TO: Planning and Zoning Commission
DATE: March 26, 2024
APPLICANT: Chris Beardon; *Wades Landing, LLC*
CASE NUMBER: SP2024-017; *Amended Site Plan for Wade's Landing at 308 Fannin Street*

PROJECT NUMBER: SP2024-017
PROJECT NAME: Amended Site Plan for 308 N. Fannin Street
SITE ADDRESS/LOCATIONS: 308 N FANNIN ST, ROCKWALL, 75087
CASE CAPTION:

SP2024-017: Amended Site Plan for an Existing Restaurant at 308 N. Fannin Street

PATIO ELEVATIONS

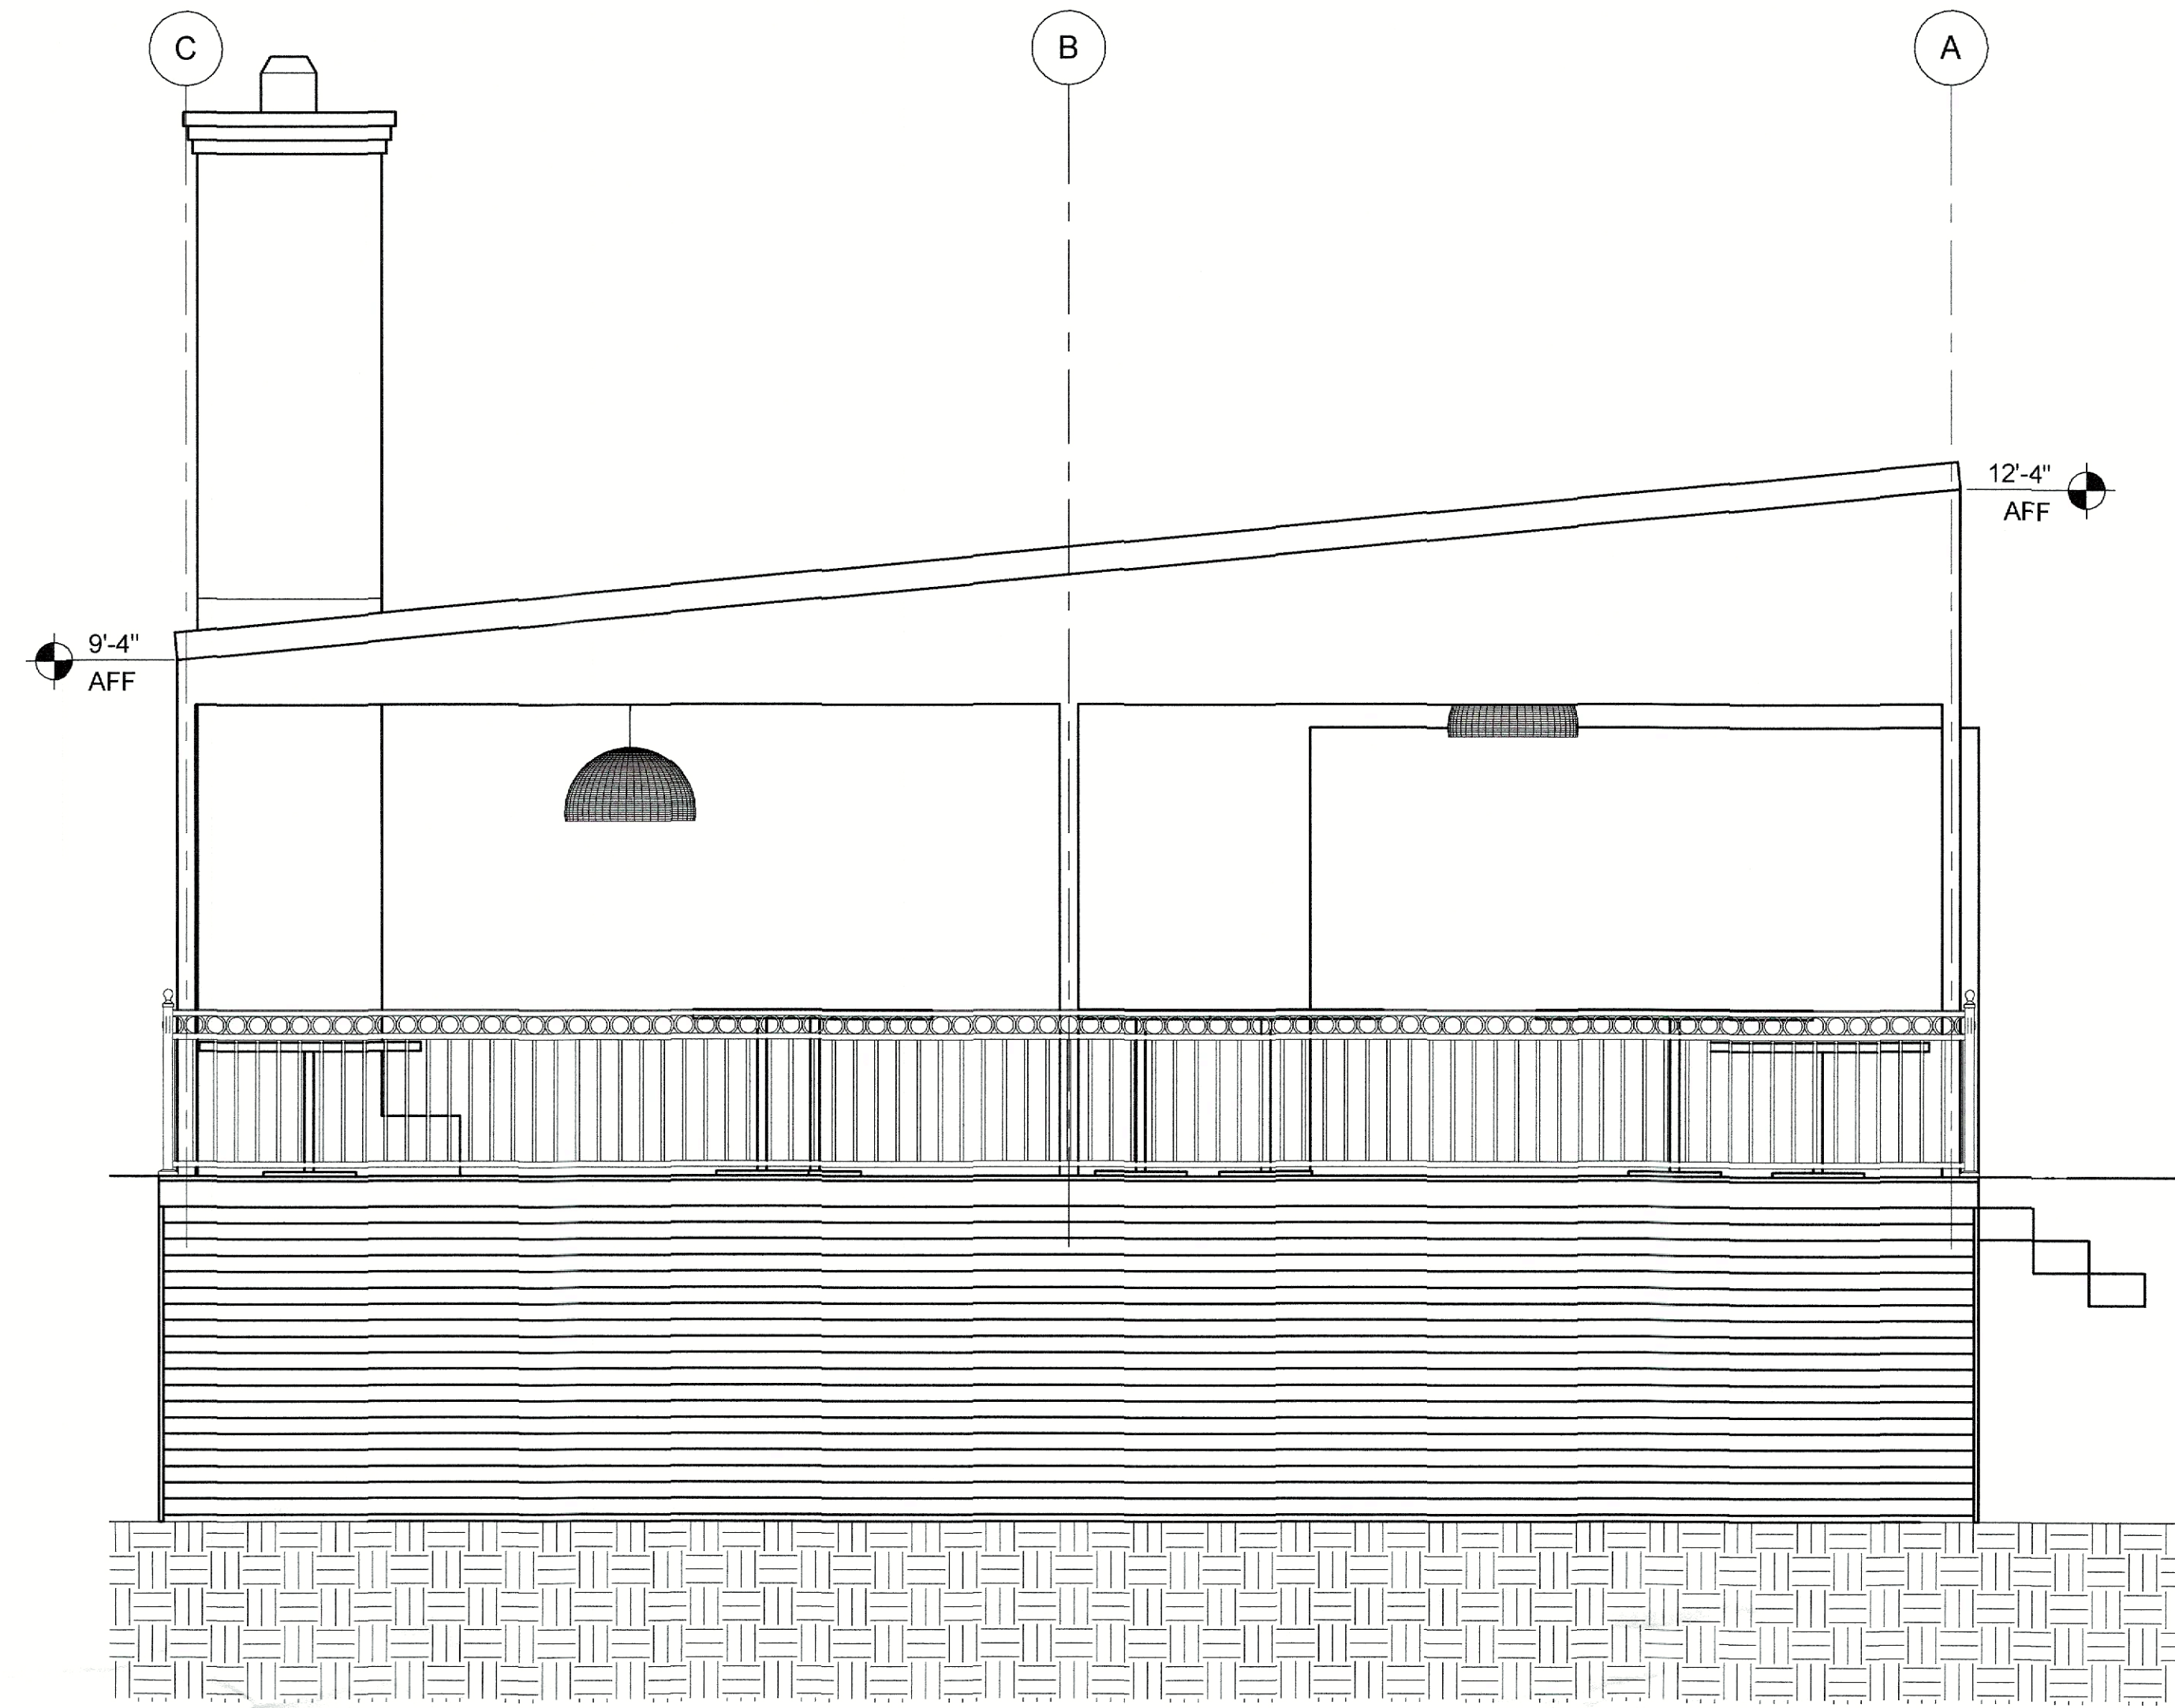
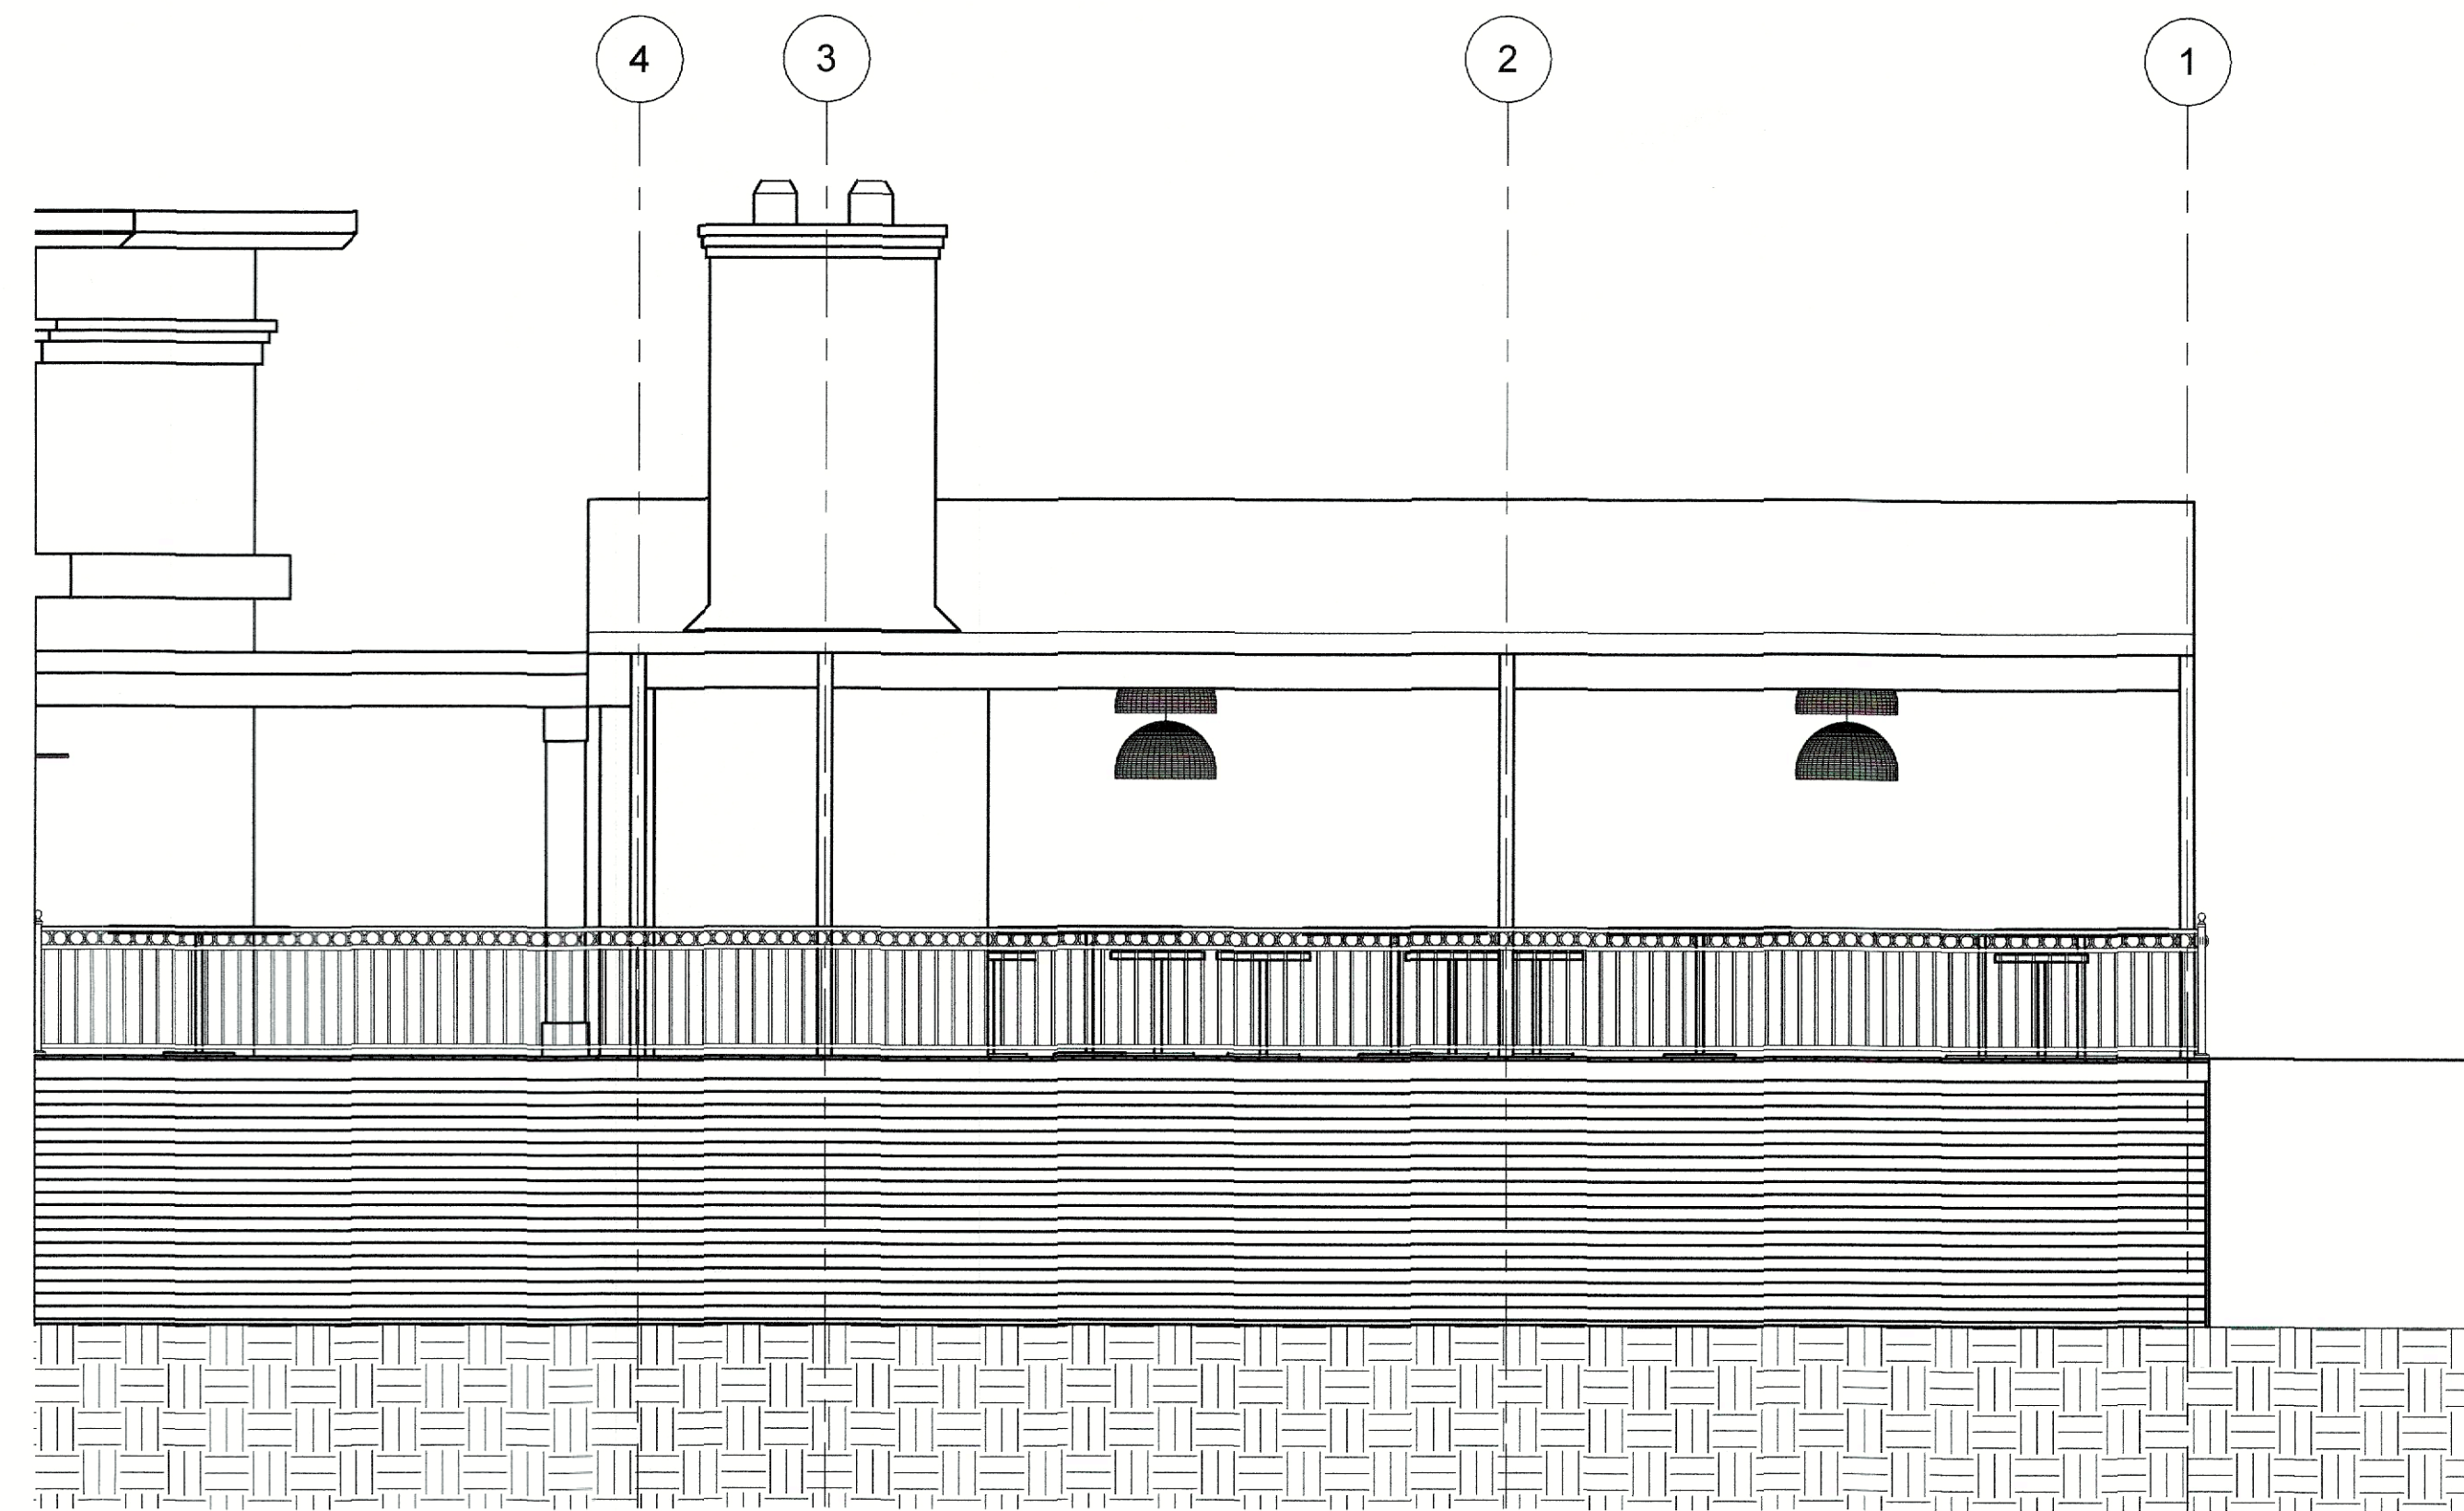
M.6 Building Elevations:

(1) If the roof is to be metal then it must be standing seam metal panels. In addition, the standing seam panels that extend down from the roof will require a Minor Waiver from the Planning and Zoning Commission. "Unpainted metal, or metal subject to ordinary rusting shall not be used as a building material. Factory finished metal elements as well as metals that develop an attractive oxidized finish, such as copper, galvanized metal, stainless steel or weathering steel, may be used as architectural accents by minor waiver approval." (Subsection 04.07. D. 2. C. 4, of Article 05, UDC)
